# Truncation of London Heathrow WOBUN and BUZAD SIDs (ACP-2017-73) – Post Implementation Review

CAP 2133

Published by the Civil Aviation Authority, 2021

**Figure 1 – The SID Truncations**

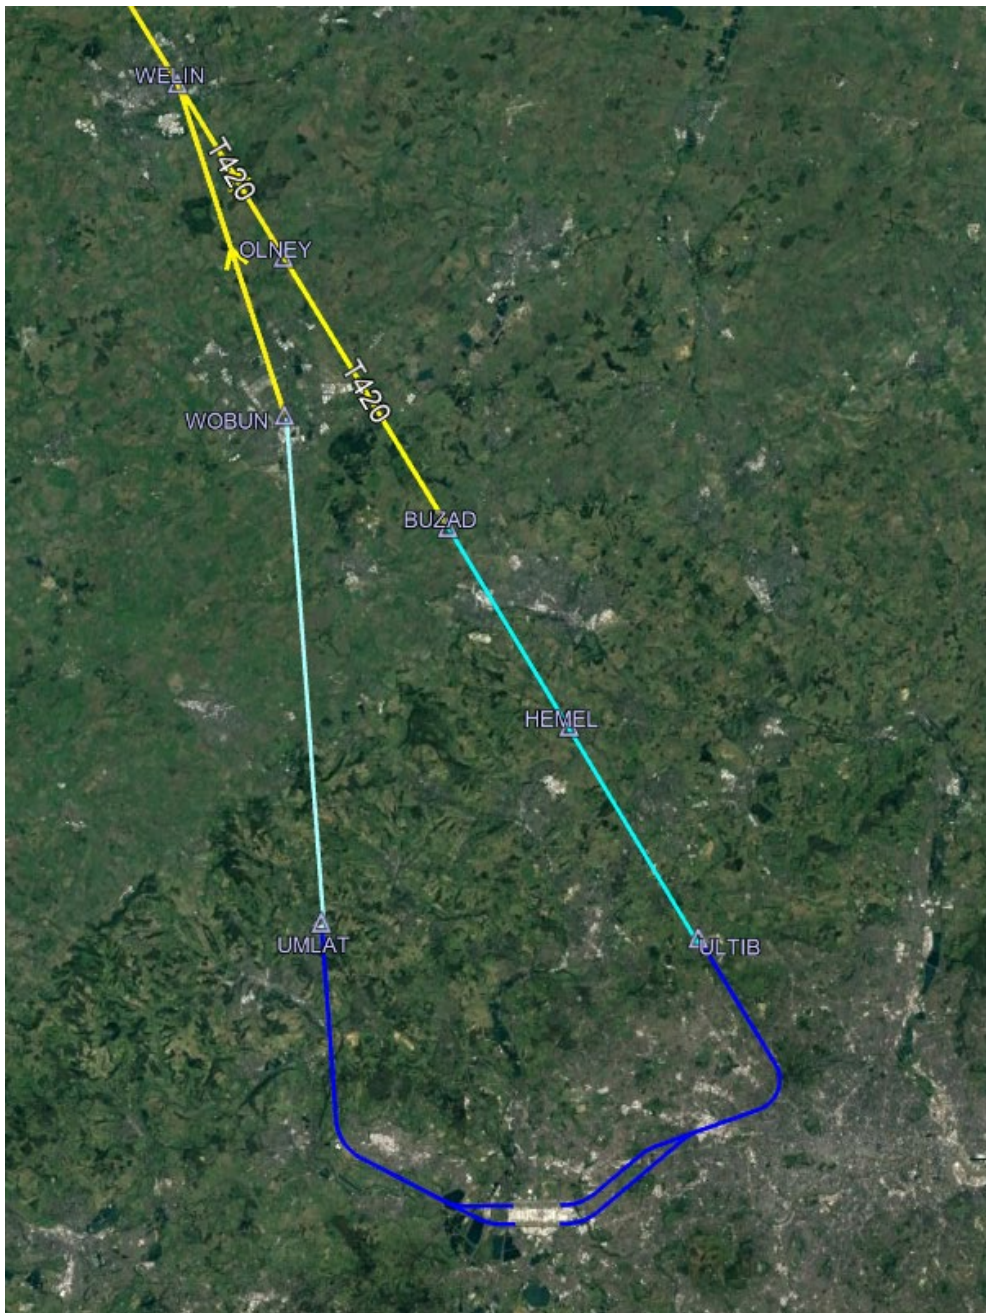
22. Figure 1 shows the truncated parts of the SIDs (light blue). The current SIDs are shown in dark blue and the relevant parts of the main route network are in yellow. Prior to the truncations, airlines would be expected to plan to fly all the way to WOBUN or BUZAD at a maximum of 6000ft, and to carry the necessary fuel accordingly. Following the truncations, airlines can plan to start climbing above 6000ft from UMLAT or ULTIB, taking the corresponding reduced fuel consumption into account.

Figure 3 – The Truncated SIDs as Published

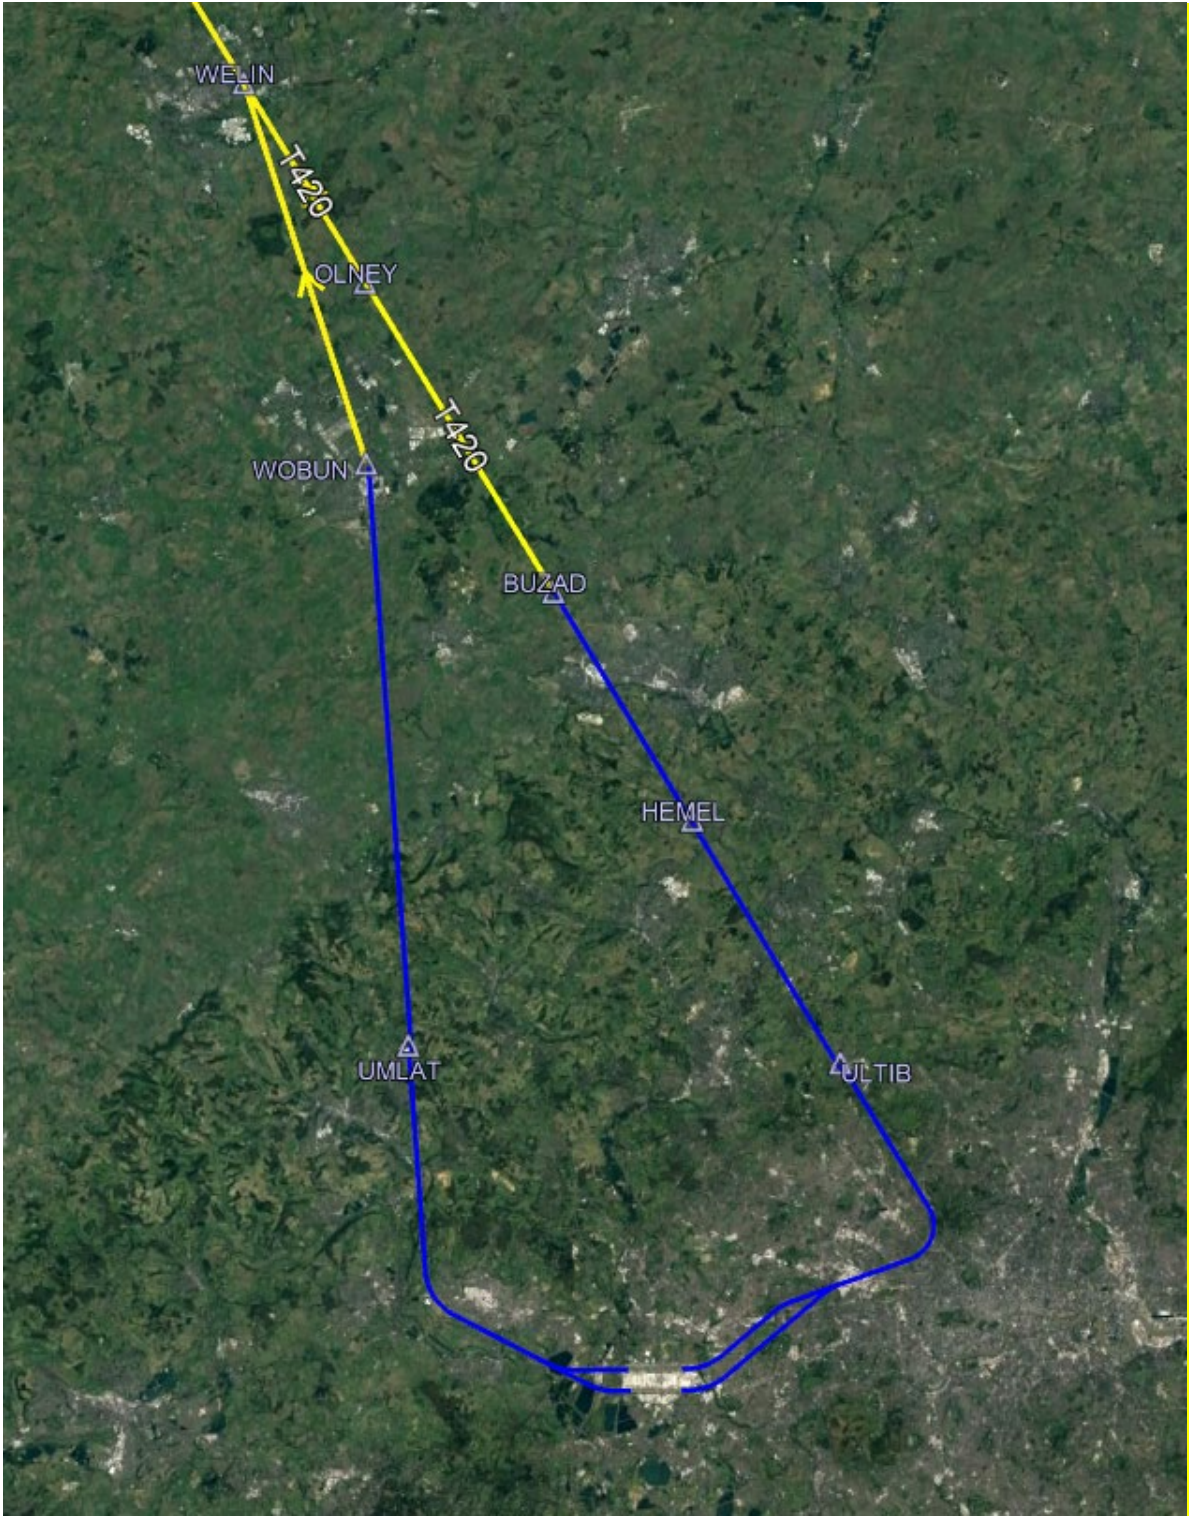
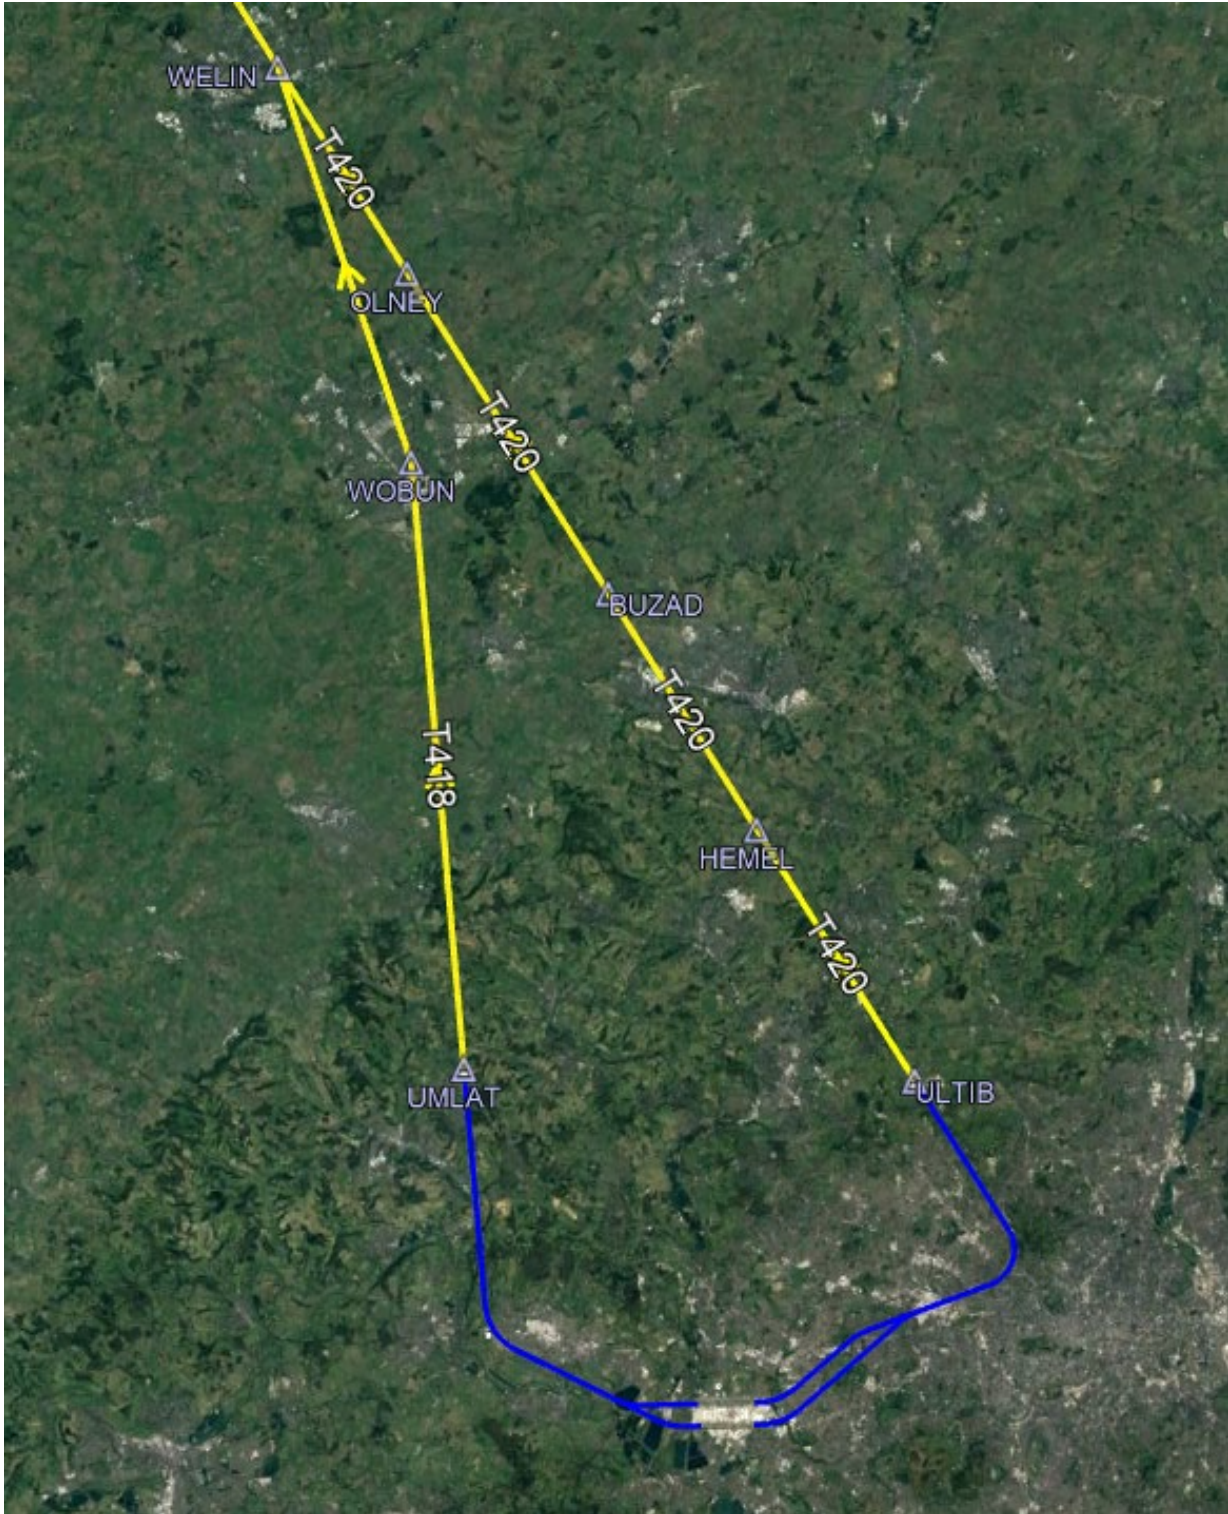
## Background to our conclusions in this PIR Decision

---

29. Airlines reported initial Flight Crew uncertainty and track deviation issues, as discussed under Safety.
30. Following the resolution of these through revised planning and briefing materials (publication of a NOTAM, adding route information to the SID descriptions in the UK AIP, additional information added to some third party SID charts), no further issues have been raised.

Figure 4 – The Incorrect Left Turn at ULTIB

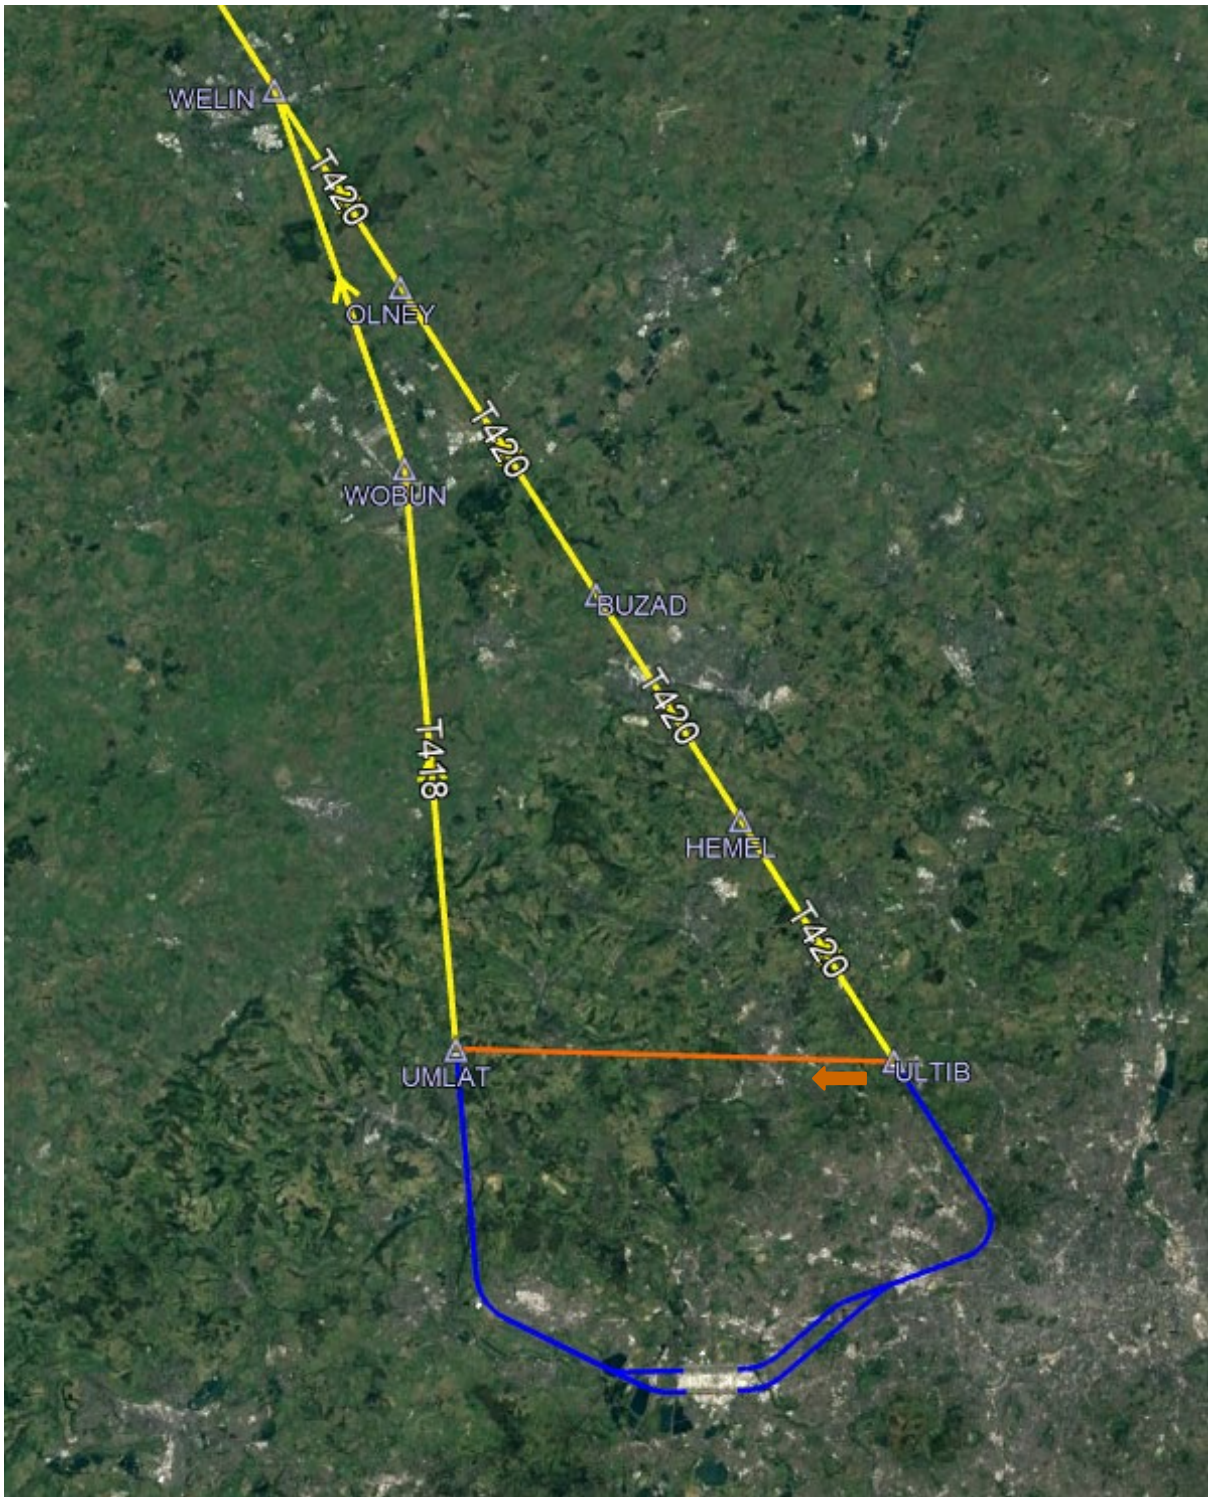
- In some cases, the path via UMLAT and WOBUN was not fully cleared from the relevant aircraft systems following the wind direction change. Some aircraft navigation systems therefore indicated that having reached point ULTIB on the ULTIB SID, the aircraft should head to point UMLAT and then head to WELIN via WOBUN, rather than going via HEMEL, BUZAD and OLNEY.

27. The short flying time between Heathrow and ULTIB meant that the situation had not necessarily been resolved by the time the aircraft reached ULTIB, turning it from a planning issue into a tactical issue.
28. In some cases, aircraft turned the wrong way in an attempt to follow their previous flight plan. In extreme cases this took them towards other traffic or airspace structures, requiring immediate resolution by air traffic controllers.

32. As both the Sponsor and the Air Navigation Service Provider, the Sponsor was responsible for ensuring the development and implementation of suitable resolutions to the issues. This involved publishing a NOTAM<sup>5</sup> in the first instance to ensure that flight crews and other relevant staff were aware of the potential issue. This was followed by a second NOTAM providing additional specific routing information. In some cases, airlines were contacted directly to draw their attention to the NOTAM if it appeared that their flight crews were not aware of it.

33. Further discussions then followed with the companies which provide the airlines with their navigation databases, and at NATS Lead Operator Panel, a forum which brings operational and flight planning experts together to discuss operational issues. The inclusion of a "reference track" to indicate the normal next direction to flight crews was raised as a potential solution, but each navigation data provider is entitled to implement a solution in the way which best works for their systems.
